THREE MILE ISLAND NUCLEAR STATION, UNIT NO. 1

AMENDMENT TO FACILITY OPERATING LICENSE

Amendment No. 78
License No. DPR-50

Replace the following pages of the Appendix "A" Technical Specifications with the enclosed pages. The revised pages are identified by Amendment number and contain vertical lines indicating the area of change.

Figure 2.3-1

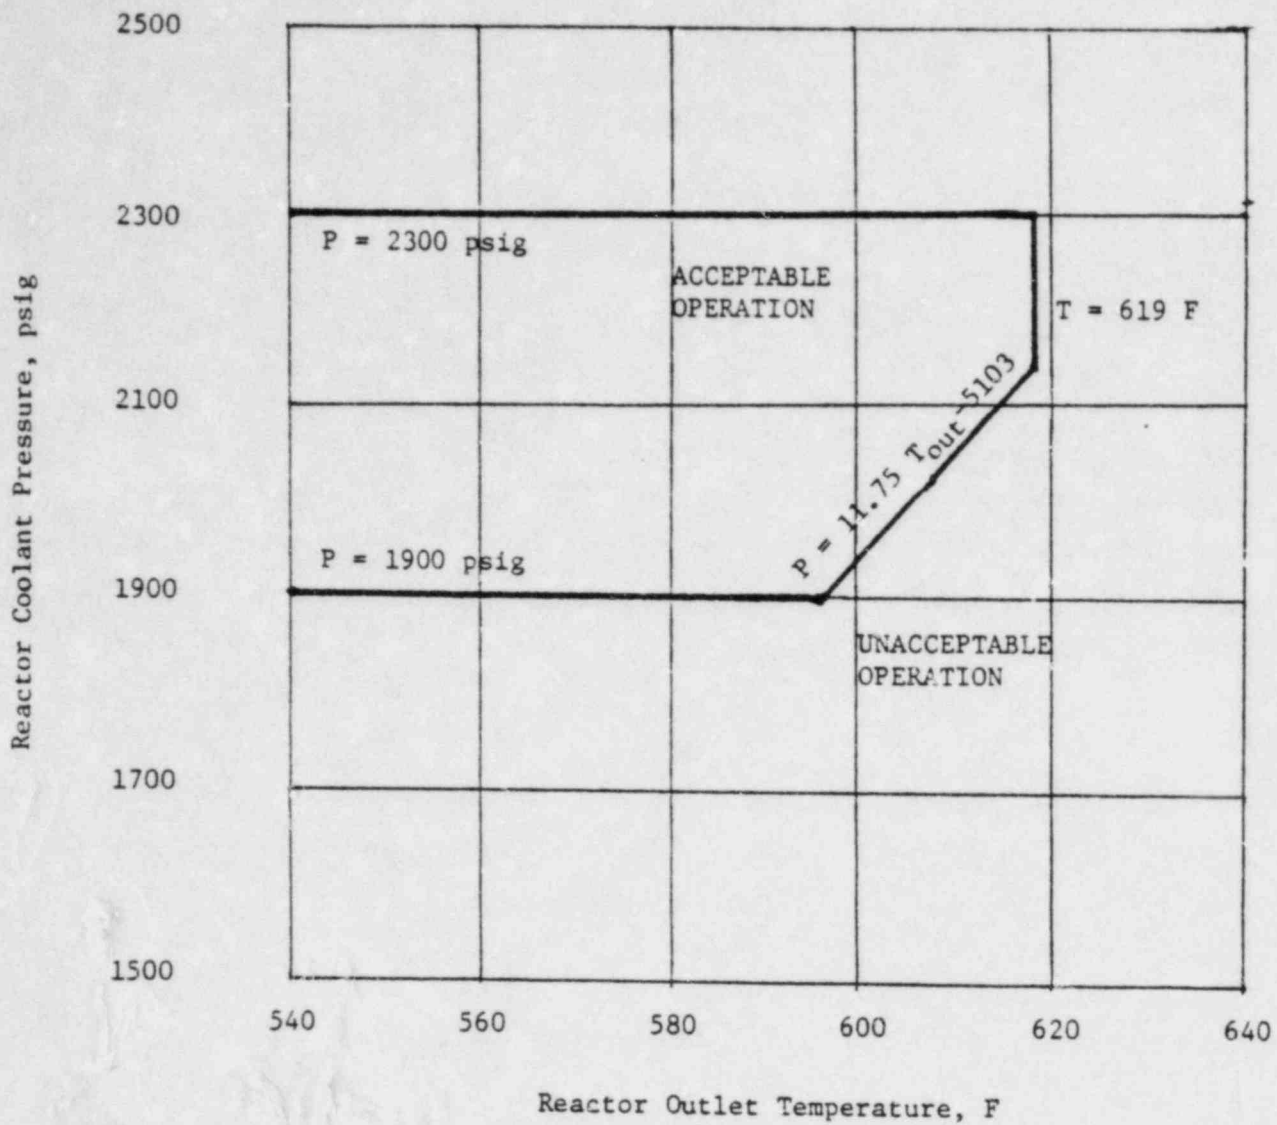
During a startup accident from low power or a slow rod withdrawal from high power, the system high pressure trip set point is reached before the nuclear overpower trip setpoint. The trip setting limit shown in Figure 2.3-1 for high reactor coolant system pressure has been established to maintain the system pressure below the safety limit (2750 psig) for any design transient (6). Due to calibration and instrument errors, the safety analysis assumed a 45 psi pressure error in the high reactor coolant system pressure trip setting.

The high pressure trip setpoint was subsequently lowered from 2390 psig to 2300 psig. The lowering of the high pressure trip setpoint and raising of the setpoint for the Power Operated Relief Valve (PORV), from 2255 psig to 2450 psig, has the effect of reducing the challenge rate to the PORV while maintaining ASME Code Safety Valve capability.

The low pressure (1800 psig) and variable low pressure (11.75 TOUT-5103) trip setpoint were initially established to maintain the DNB ratio greater than or equal to 1.3 for those design accidents that result in a pressure reduction (3,4). The B&W generic ECCS analysis, however, assumed a low pressure trip of 1900 psig and, to establish conformity with this analysis, the low pressure trip setpoint has been raised to the more conservative 1900 psig. Figure 2.3-1 shows the high pressure, low pressure, and variable low pressure trips.

The high reactor coolant outlet temperature trip setting limit (619 F) shown in Figure 2.3-1 has been established to prevent excessive core coolant temperature in the operating range.
